<b>Docket Number:</b>	17-HYD-02
<b>Project Title:</b>	Hydrogen Station Network Future Approaches
<b>TN #:</b>	222052
<b>Document Title:</b>	Joe Gagliano Comments Industry Stakeholder Comments - HRS Technical Requirements (2 of 2)
<b>Description:</b>	N/A
<b>Filer:</b>	System
<b>Organization:</b>	Joe Gagliano
<b>Submitter Role:</b>	Applicant Representative
<b>Submission Date:</b>	12/22/2017 3:21:18 PM
<b>Docketed Date:</b>	12/22/2017

**Industry Stakeholder Comments - HRS Technical Requirements (2 of 2)**

## SUMMARY OF PROPOSED CHANGES

GFO-15-605 LDV HRS INFRASTRUCTURE APPLICATION MANUAL	2017 FUTURE GFO RECOMMENDATIONS
<b>V. OVERALL ELIGIBILITY REQUIREMENTS</b>	
<b>B. PROJECT REQUIREMENTS</b>

## Fueling Position Example Diagram

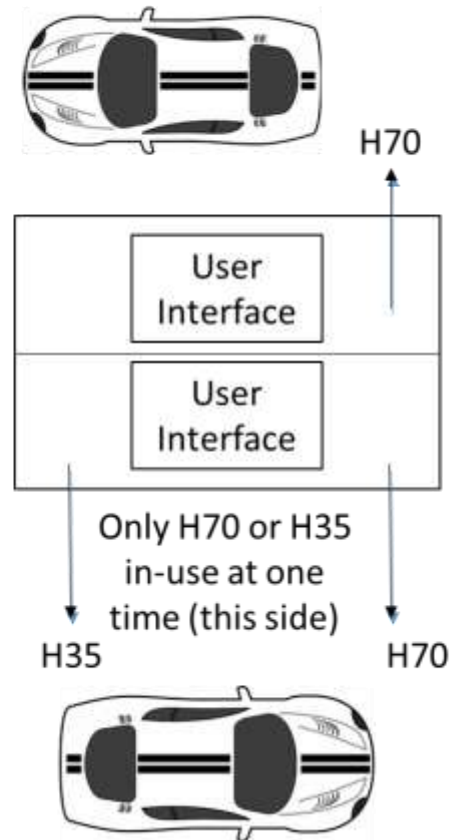
A station in a "cluster" area shall have a minimum of 2 fueling positions. A "connector" or "destination" station may install only 1 fueling position, but the site layout shall not preclude the future addition of a second fueling position.

A single fueling position is defined as an H70 fueling interface with a dedicated customer vehicle access, user control, and point of sale interface. The fueling position may also include an H35 nozzle, in addition to, the H70 nozzle. For a station with multiple fueling positions, each fueling position shall be capable to operate independently and in-parallel (simultaneously).

[see enclosed diagram below]

Each fueling position station shall have the capability to dispense a minimum average daily capacity of no less than ~~160~~ 180 kg. Applicants will be required to adhere to the minimum daily fueling capacity proposed in their application. Minimum daily fueling capacity refers to the station's capacity to fuel light duty vehicles over a 12-hour period, between 6 a.m. and 6 p.m. on a daily basis.

Each fueling position shall have the capability to dispense a minimum of 200 kg over a period of 24-hours (6 a.m. to 6 a.m.) on a daily basis. Stations which require a batch process such as resupply from delivered gas, or recovery period for production or compression processes, must include the delay caused by this process step over the 24-hour period. The 24-hour fueling capacity shall also represent a repeatable value such that fueling could occur on consecutive days between periods of planned maintenance.
